HISTORIC AND DESIGN REVIEW COMMISSION

February 02, 2022

HDRC CASE NO: 2022-045
ADDRESS: 926 LAMAR ST
LEGAL DESCRIPTION: NCB 1655 BLK C LOT 21 495-123753-203
ZONING: R-5, H
CITY COUNCIL DIST.: 2
DISTRICT: Dignowity Hill Historic District
APPLICANT: Bryan Sory
OWNER: Bryan Sory
TYPE OF WORK: Demolition of Accessory Structure
APPLICATION RECEIVED: January 12, 2022
60-DAY REVIEW: Not applicable due to City Council Emergency Orders
CASE MANAGER: Rachel Rettaliata

The applicant is requesting approval for the demolition of the rear accessory structure.

NORTH ELEVATION

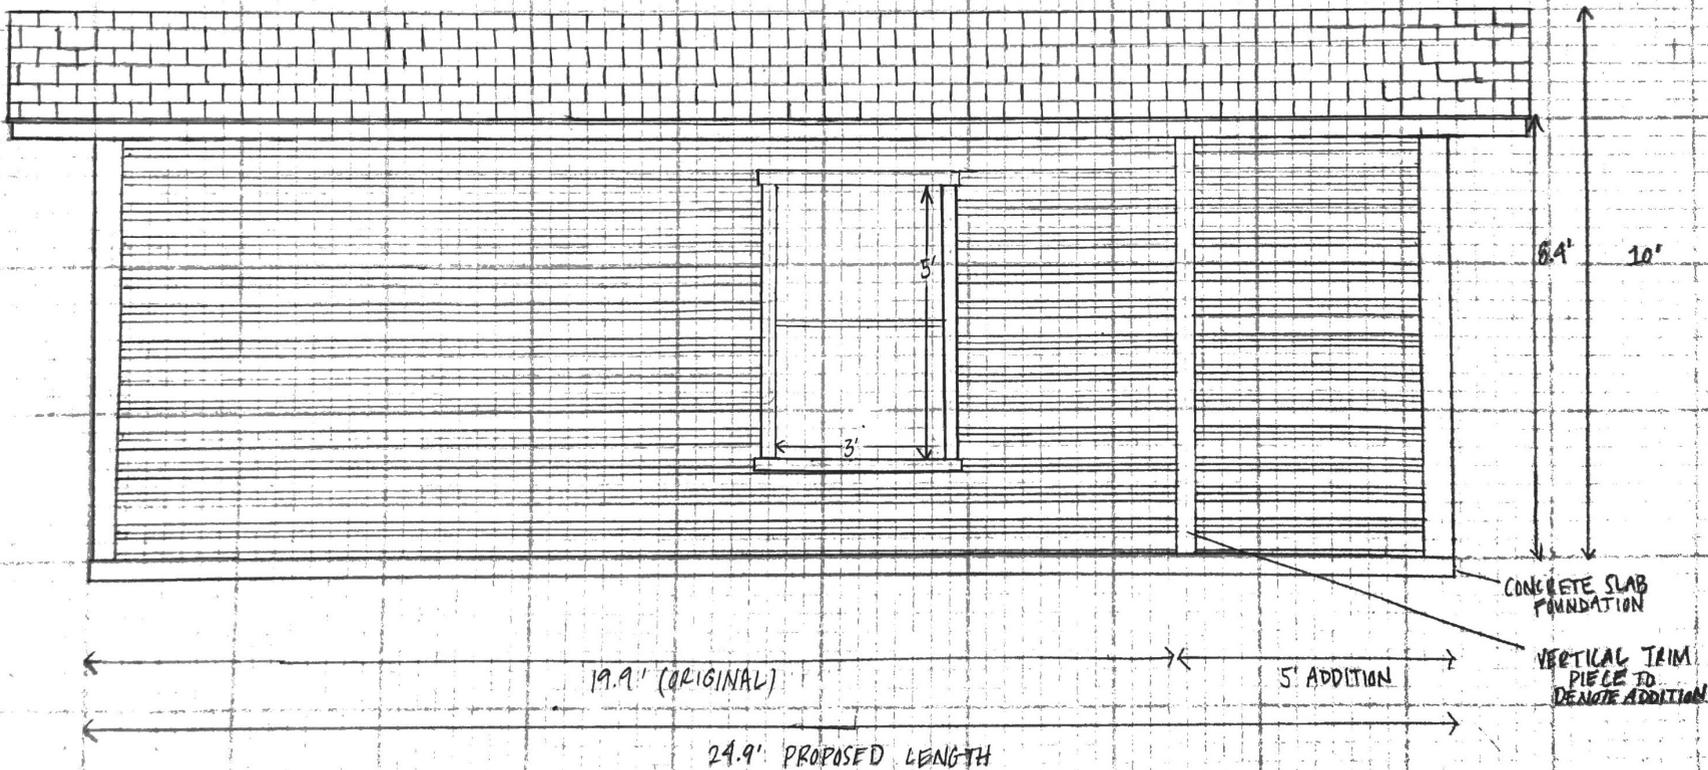
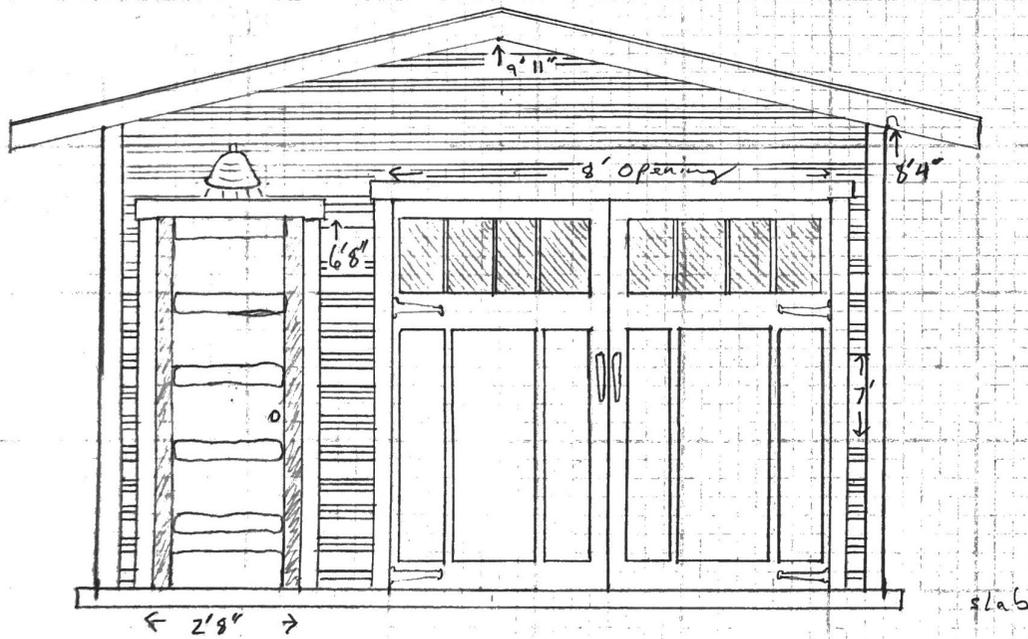
- * Rear El. =>
- ① Match Siding Pattern
 - ② No openings
 - ③ Same Dimensions
